コーニングインターナショナル株式会社
ライフサイエンス事業部**Corning® ピペット一部製品**
外箱・二次包装デザイン一部変更のご案内

さて、2021年9月21日にご案内しました Corning ピペットの一部製品の個別包装仕様変更に関して、外箱と二次包装のデザインが一部変更となりますのでご案内申し上げます。本変更に伴う製品の仕様や機能性に変更はございません。また製造中ならびに製造後の検査にも変更はございません。

(変更例) 二次包装

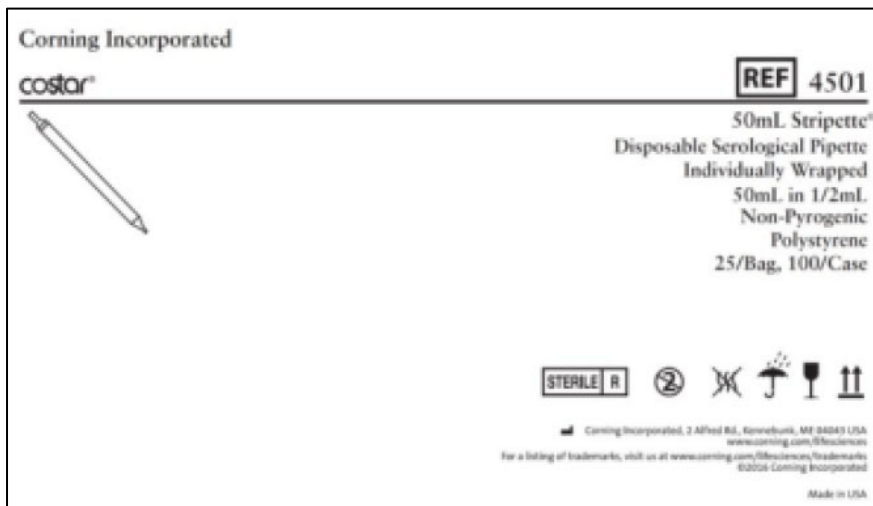
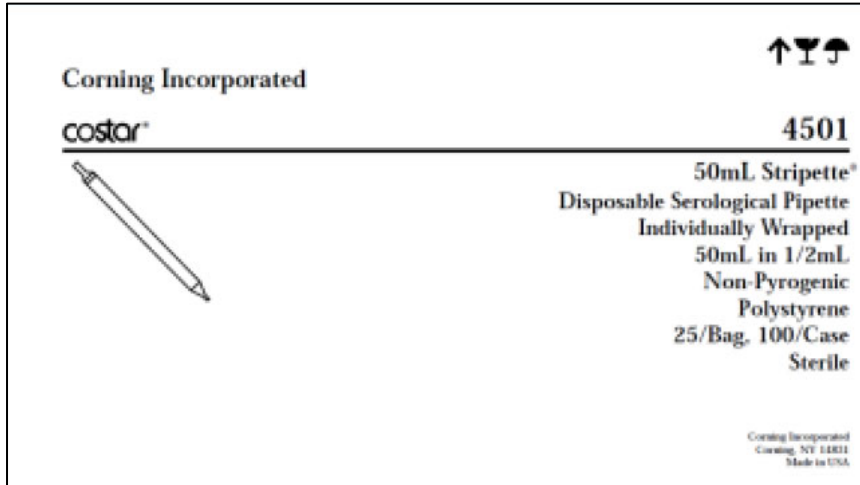
1. カタログ番号の前にREFマークを追加
2. “Sterile”表記を削除
3. その他下記内容を変更
 - A) 放射線滅菌済みを示す記号を追加
 - B) 一回のみの使用/再使用不可を示す記号を追加
 - C) ノンパイロジェニックを示す記号を追加
 - D) 製造拠点を示す記号を追加
 - E) 製造拠点の住所をニューヨーク州からメイン州に変更
 - F) トレードマークに関する情報とウェブサイトの記載を追加
 - G) 警告文を削除（二次包装のみ）
 - H) 輸送に関する記号3つを右上から右下へ移動（外箱のみ）
